**TOWN OF MOUNTAIN VILLAGE
REGULAR DESIGN REVIEW BOARD MEETING AGENDA
THURSDAY MAY 1, 2025, 10:00 AM
MOUNTAIN VILLAGE TOWN HALL
455 MOUNTAIN VILLAGE BLVD, MOUNTAIN VILLAGE, COLORADO
TO BE HELD HYBRID THROUGH ZOOM:
<https://us06web.zoom.us/j/85097485733>
Meeting ID: 850 9748 5733**

Case Summary: Chris Hawkins of Alpine Planning is requesting Design Review Board (DRB) approval of an Initial Architectural and Site Review (IASR) for a new single-family detached condominium on Lot 161A-4 Unit 8, TBD Raccoon Lane. The lot is approximately 0.16 acres and is zoned multi-family. The proposed design consists of a two-story structure. The overall square footage of the home is approximately 7,543 gross square feet. Because of the home's location near the top of Coonskin Ridge, additional development regulations must be addressed in addition to the general Design Review Standards – specifically, CDC Section 17.5.16: Ridgeline Lots. The applicant has provided all the required materials for the IASR for the proposed home.

Utilities

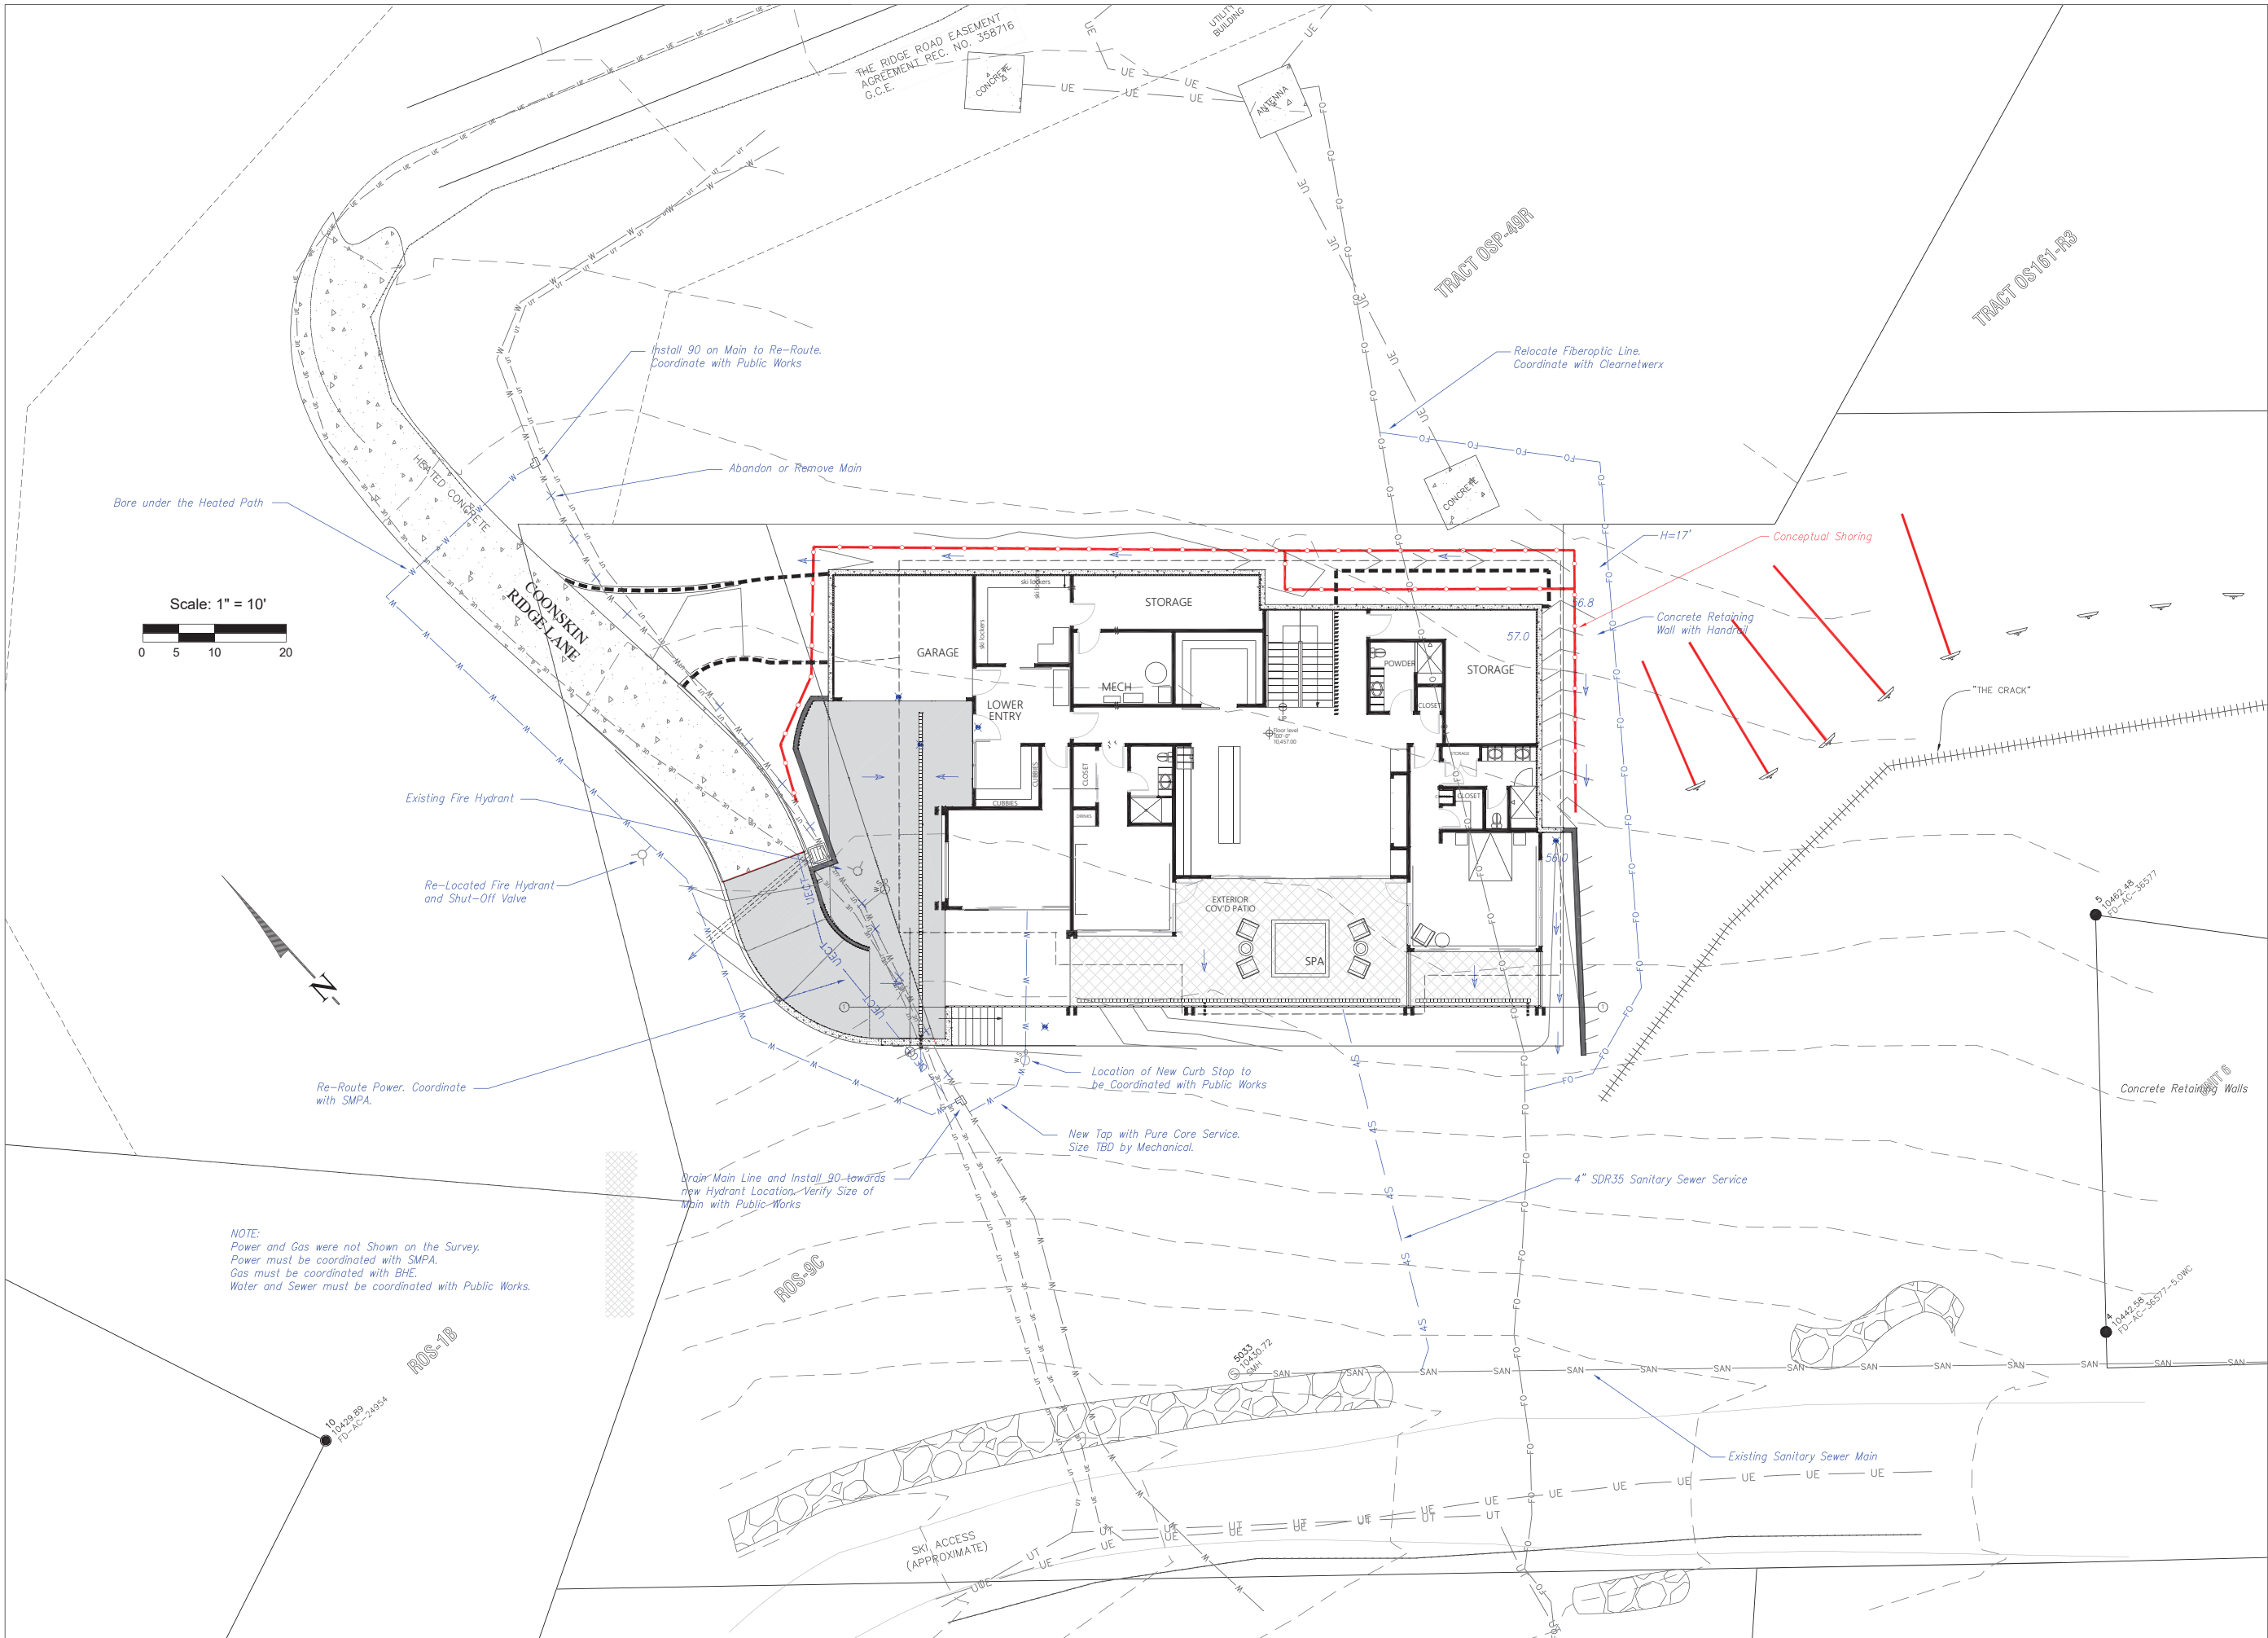
Staff: A revised utility plan was provided on Sheet C3. The water line will be rerouted adjacent to the cart path and cross the cart path to connect to the main line. The utility line will connect to the cart path. The sewer line is shown running up the hillside to connect to the back of the house. The applicant will need to work with public works to reroute or abandon the main lines. The utilities will need to be field verified.

C3

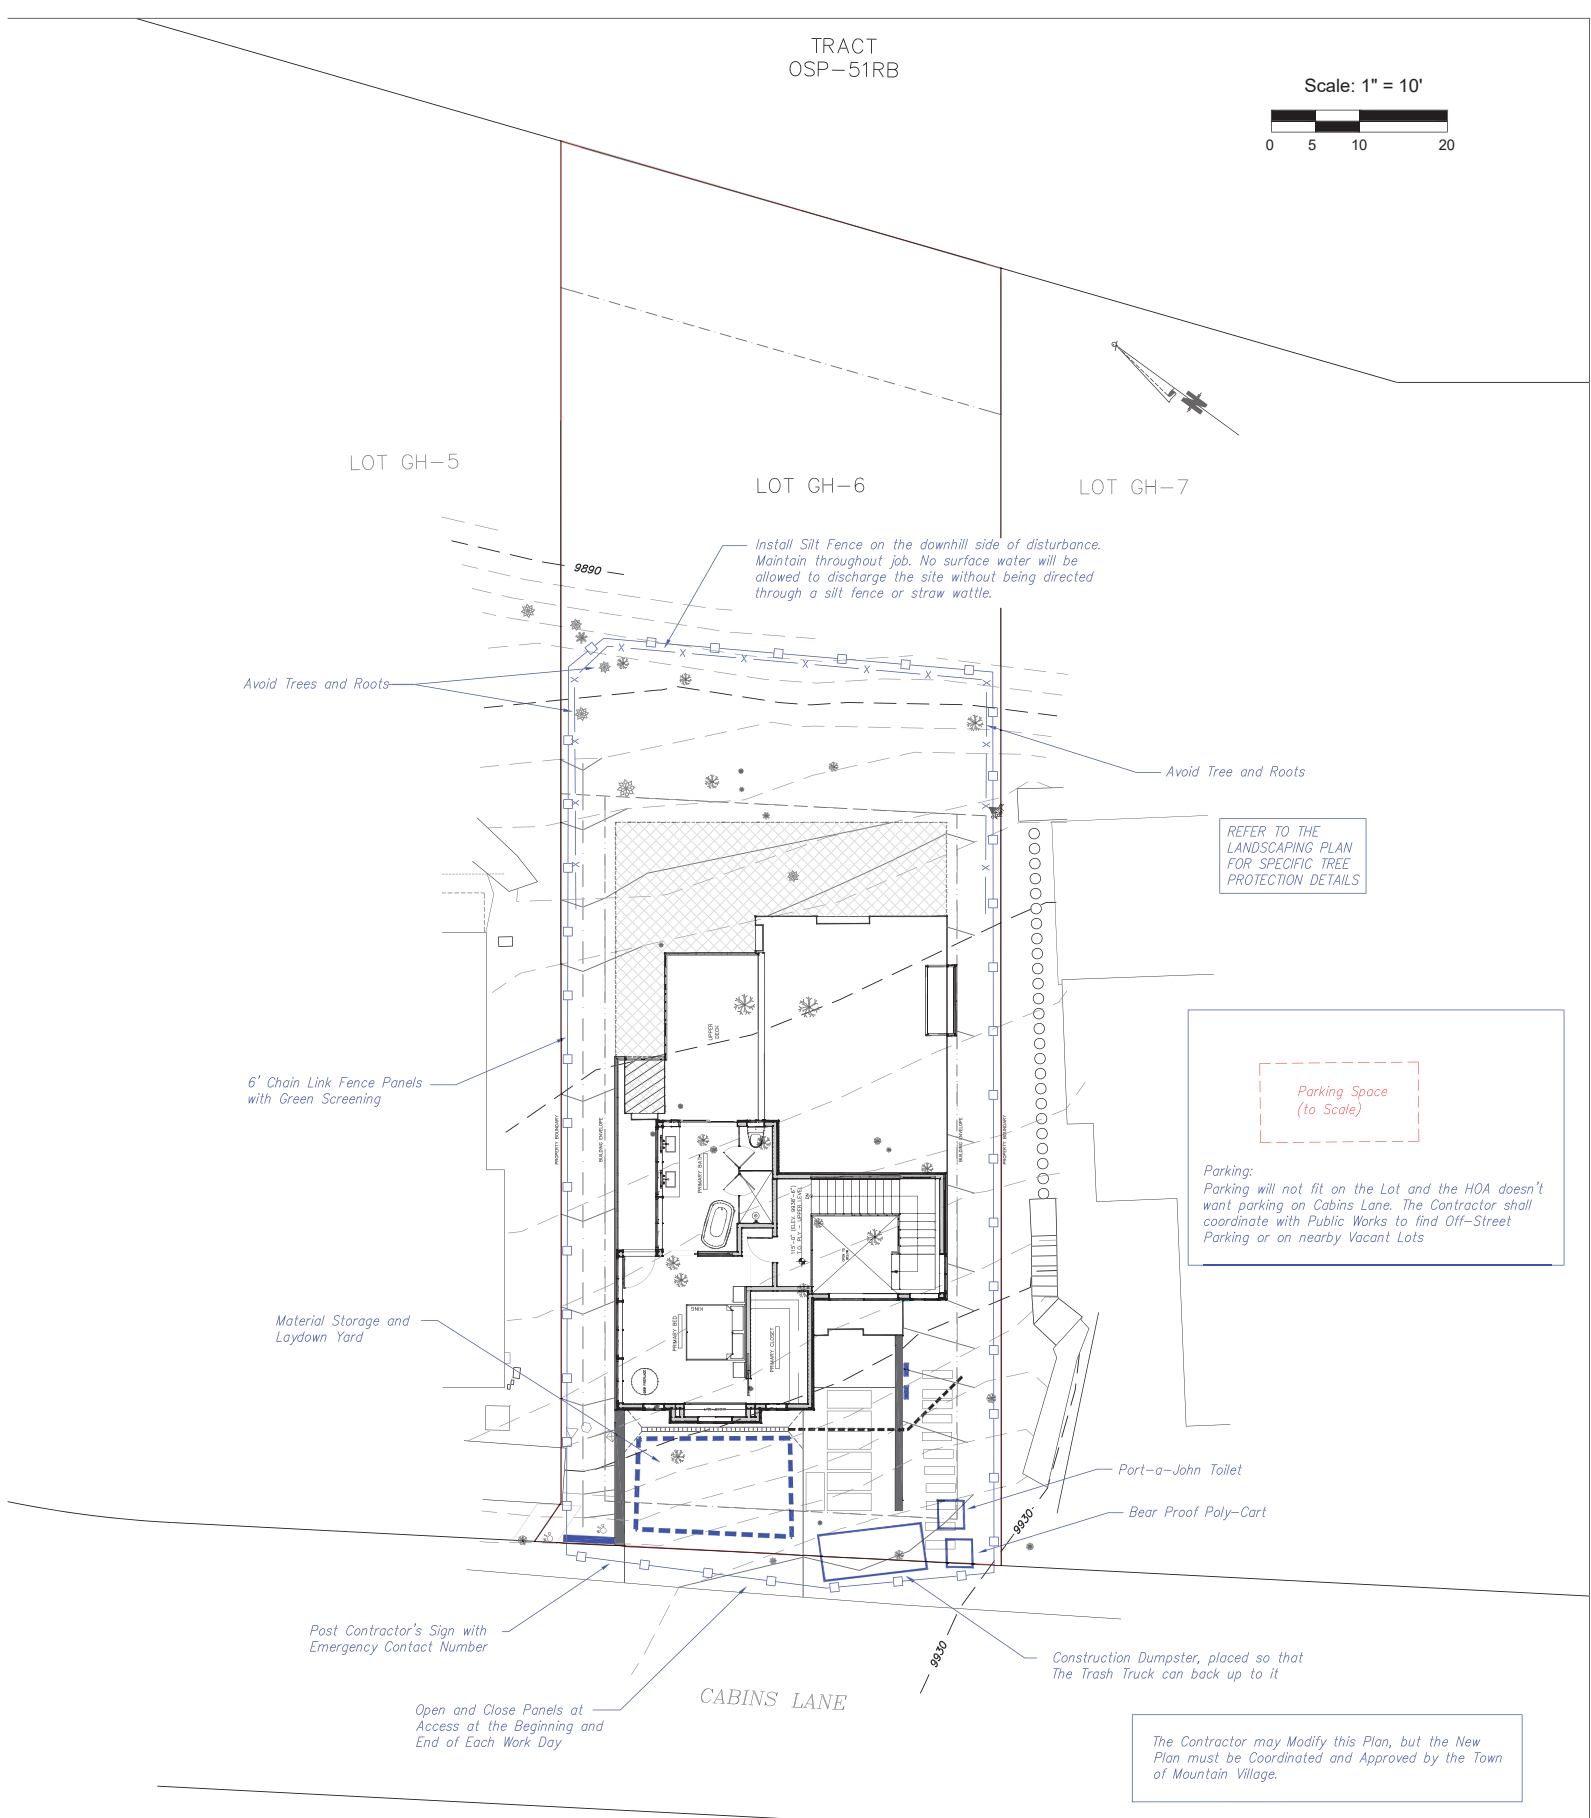
- *Utilities: The applicant has provided a utility plan for Lot GH-6 demonstrating the proposed locations of utility lines and connections. The sewer and water lines are shown running up the driveway to connect to the home. The utility and gas lines are shown crossing the front setback to connect to meters on the side of the home.*
- *Landscaping: A 2' dry-stack landscape wall is shown in the front setback for retainage on Sheet C2.*
- *Driveway and retaining wall: The driveway as shown takes access from Cabins Lane and crosses the setback to the home. A retaining wall next to the driveway encroaches into the front setback.*

A107

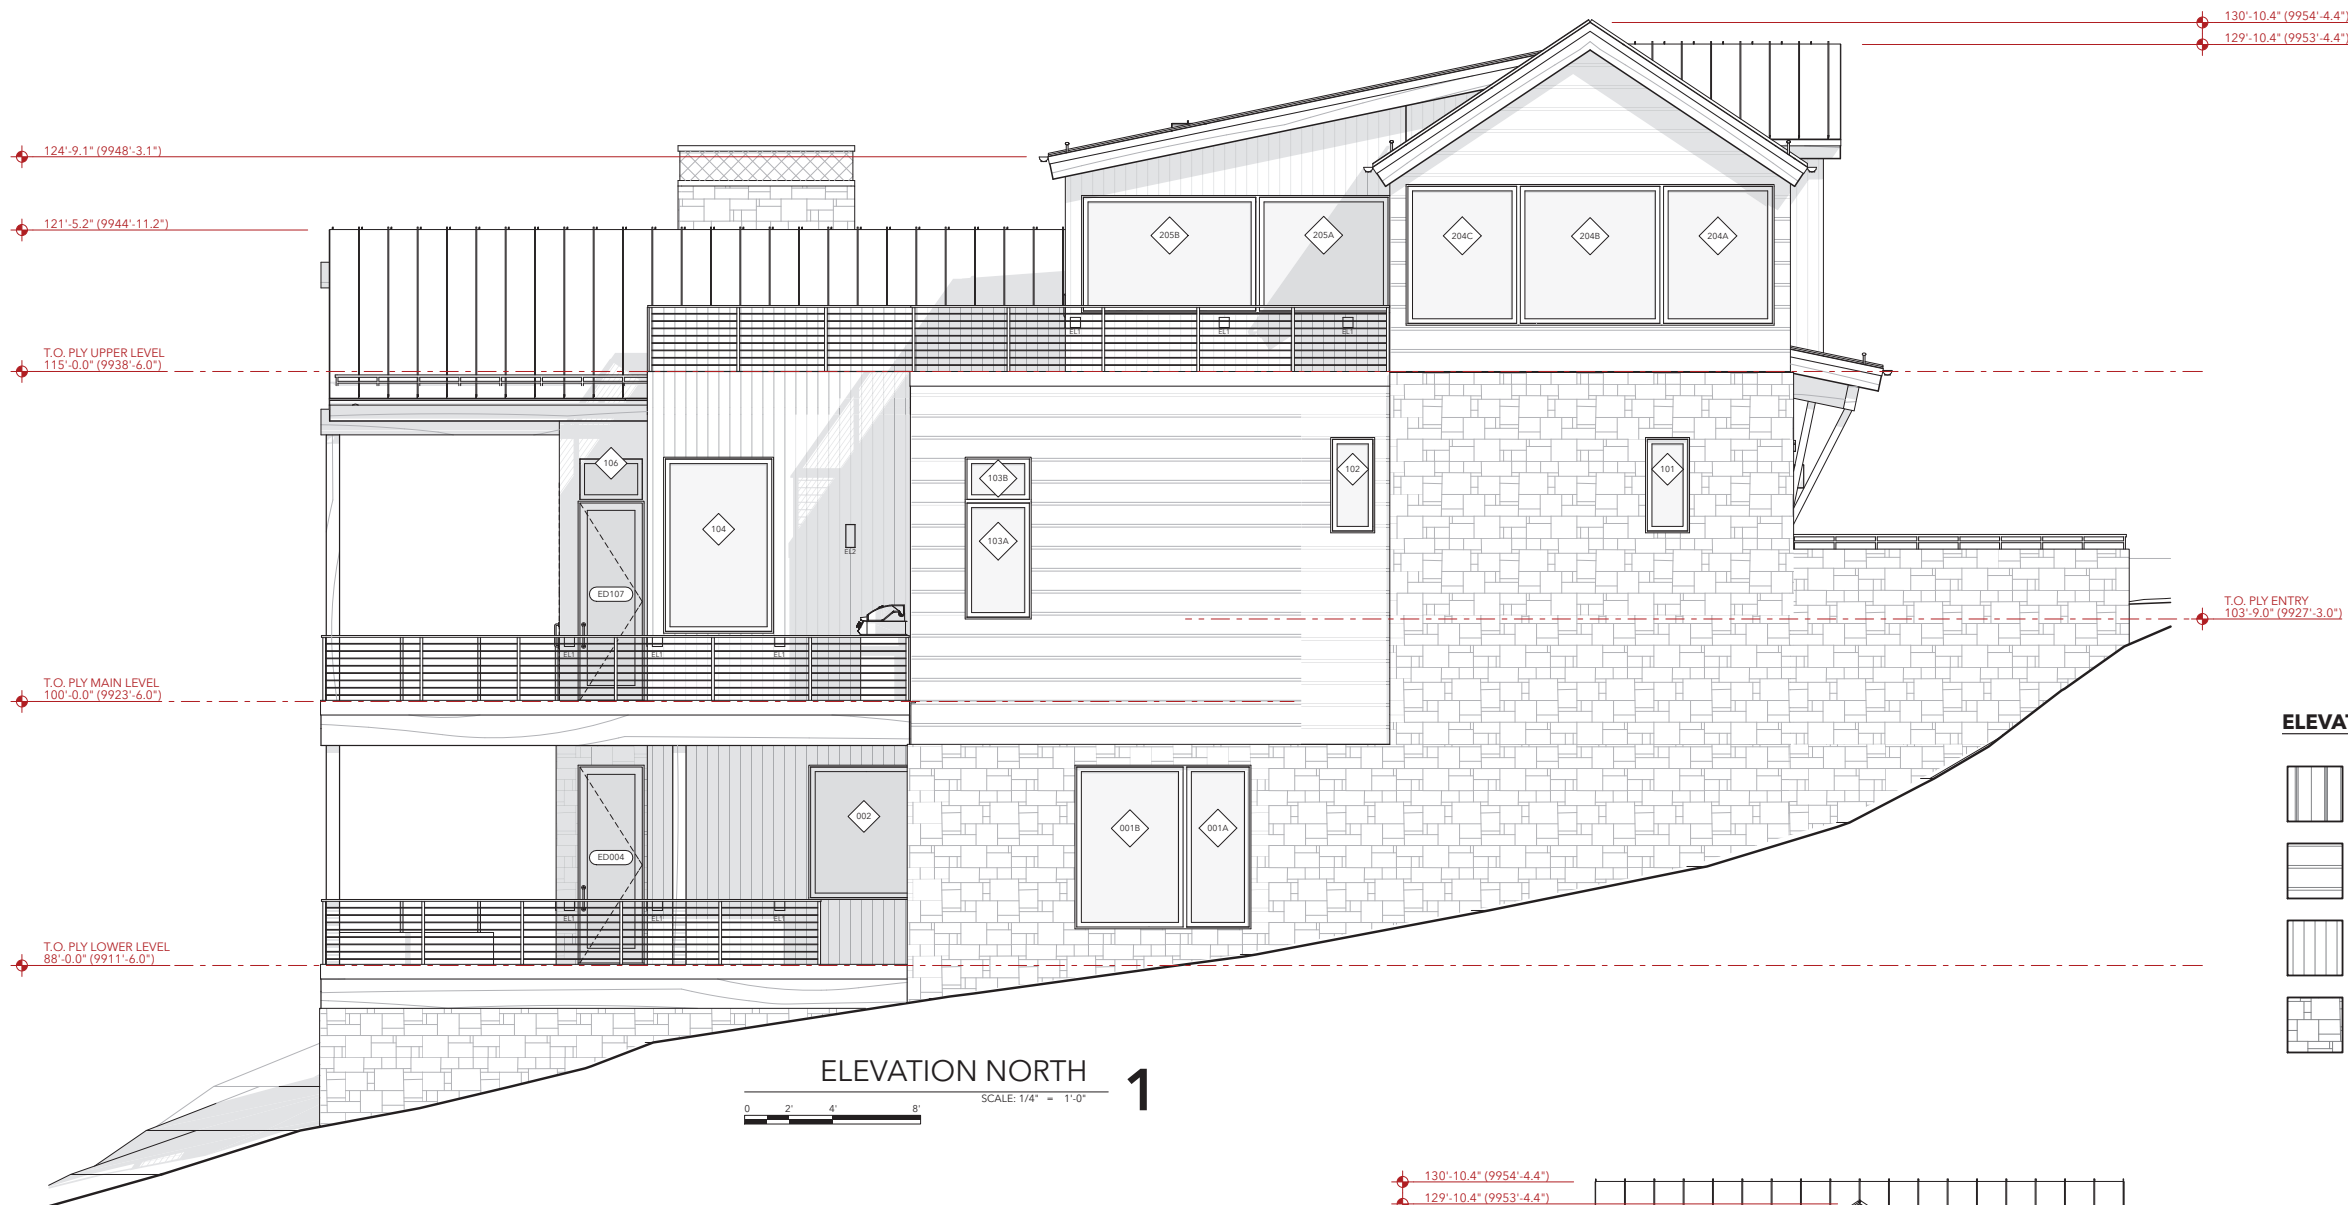
Staff: A lighting plan has been provided on Sheets A105-A107. The applicant has proposed utilizing a recessed can, sconce, and step light. The fixtures proposed are dark sky and CDC compliant. The applicant has proposed a minimal number of light fixtures. The fixtures are mainly proposed at doors and pathways. Because of this, the applicant has requested to waive the requirement for a photometric study. The DRB should discuss if the photometric study should be waived.
